Market Procedure for Maximum Reserve Capacity Price

Wholesale Electricity Market – Procedure Change Proposal

Procedure Change No: PC_2011_XX

MARKET PROCEDURE: Maximum Reserve Capacity Price

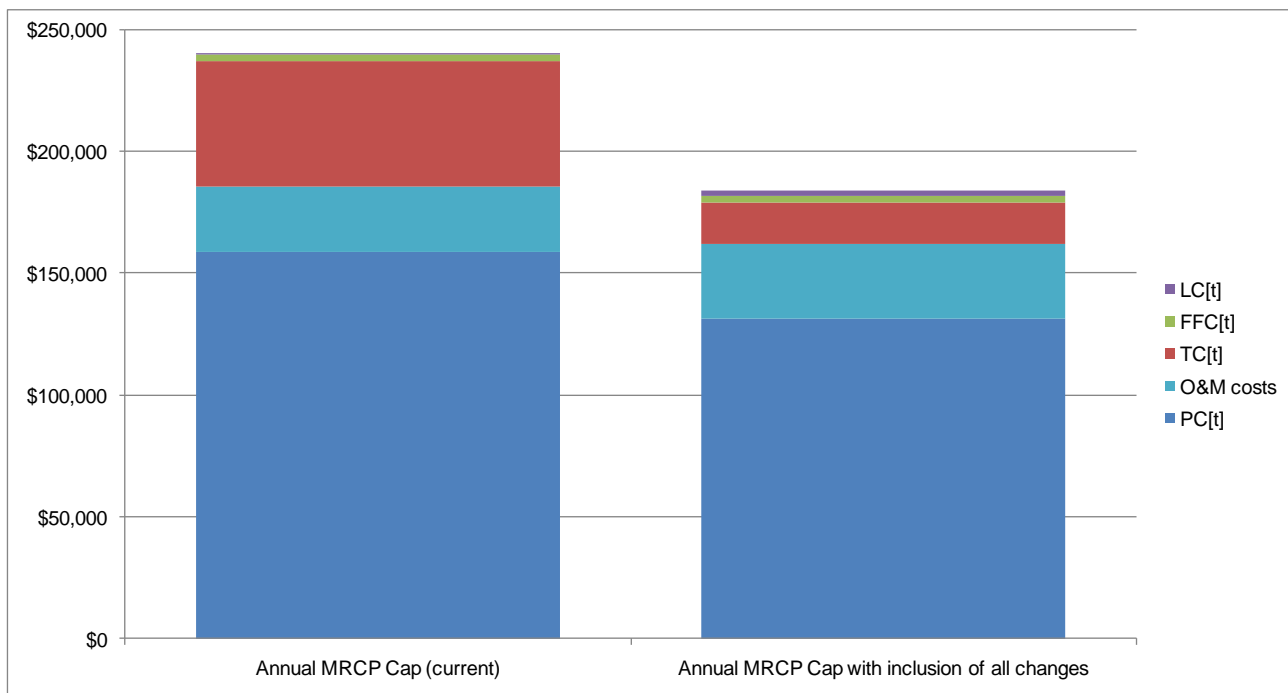
The graph shown below illustrates the relative contribution of the various component costs to the total MRCP, both under the current methodology and under a methodology where all of the changes listed in the table above are implemented. A comparison for implementation of the revised DRP methodology has not been included as the proposed amendments to the Market Procedure provide an option to use an alternative methodology rather than a requirement to do so.

Capacity Year	13/14 current	13/14 indicative
Power Station Cost	\$ 158,710	\$ 131,261
Transmission Costs	\$ 51,621	\$ 17,137
Fixed O & M	\$ 26,649	\$ 30,805
Fuel Costs	\$ 2,825	\$ 2,608
Land Costs	\$ 818	\$ 2,163
MRCP (nearest \$100)	\$ 240,600	\$ 184,000
